MARINE AND COASTAL ACCESS ACT (2008). FOLLOWUP CONSULTATION FOR THE APPLICATION FOR THE TEES SOUTH BANK DEVELOPMENT PHASES 1 AND 2 BY THE TEES SOUTH BANK CORPORATION (TSBC) AT RIVER TEES, MIDDLESBOROUGH.

Reference Number: MLA/2020/00506 (MLA/2020/00507)

From: Joe Perry
Cefas, Lowestoft Laboratory
Date: 18th June 2021
Tel: 01502 524564
E-mail: regulatory_assessment@cefass.co.uk

Figure 1. Bar chart depicting BDE results for congeners 100, 153, 154, 17, 183, 28, 66 and 85.

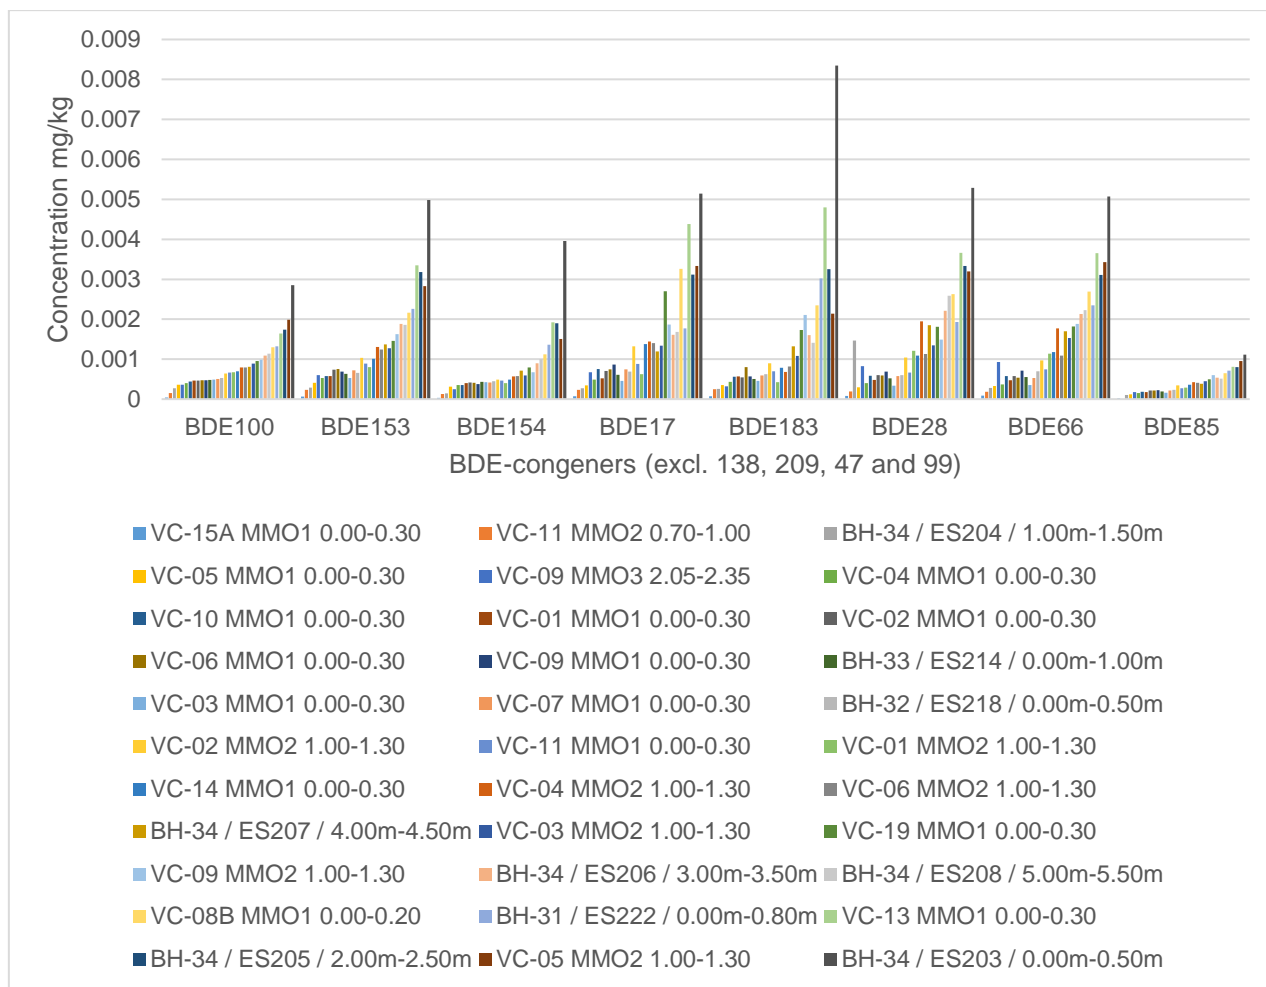
15. The results generally depict a broad range of PBDE levels throughout the dredge areas, with approximately half of all samples recording levels below the limit of detection (LOD) for all PBDEs. Levels generally appear consistent with what would be expected for the various BDE congeners in the River Tees, i.e. BDE138 is either below, or marginally above the LOD in all samples, whilst BDEs 47, 99 and 209 all depict higher relative concentrations than the other congeners. Figure 1 details the results for all BDE congeners except for BDEs 139, 209, 47 and 99.

17. The results in Figure 1 indicate that many results for BDE100 (median = 0.0006 mg/kg) exceed the FEQG, whilst all results for BDE153 are well below the respective FEQG. All other results (excl. BDEs 47, 99 and 209) are clearly consistent with data presented for the Northern Gateway Container Terminal (MLA/2020/00079) and Tees and Hartlepool Maintenance Disposal Licence (MLA/2015/00088/4) in the surrounding area, and therefore, whilst there is limited resource with which to judge PBDE results, the results (excl. BDEs 47, 99 and 209) do not preclude material from disposal at sea at this time.
18. BDEs 47, 99 and 209 are typically observed at higher concentrations relative to all other BDEs, particularly in the Tees. Figure 2 details the results for BDEs 47 and 99, whilst Figure 3 details the results for BDE 209.

Figure 2. Bar chart depicting BDE results for congeners 47 and 99

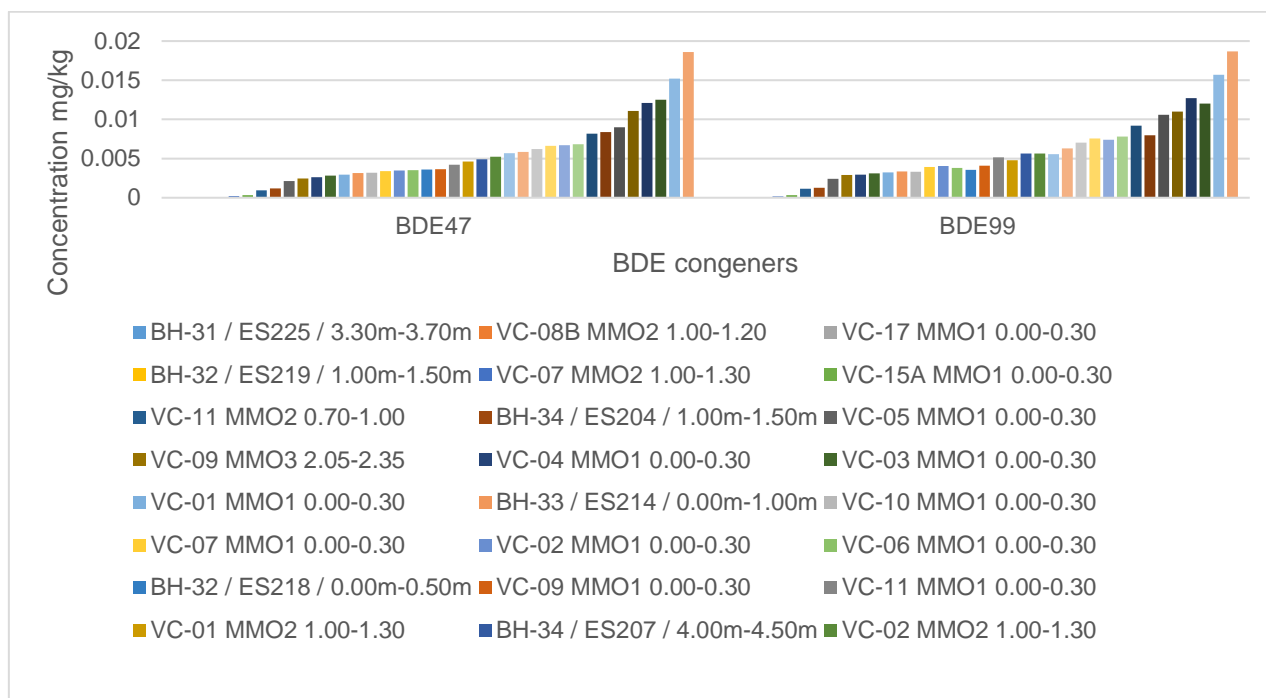
19. Figure 2 indicates that results for BDE 47 are all well below the FEQG, whilst most results for BDE 99 are above the respective FEQG. Results for BDE 209 show a mix of results below and above the respective FEQG. In comparison to previous PBDE data from the surrounding area (MLA/2020/00079 and MLA/2015/00088/4), the BDE 47 and 99 results appear largely consistent, whilst BDE 209 results appear generally lower. In this regard, the results do not preclude material from disposal at sea at this time.
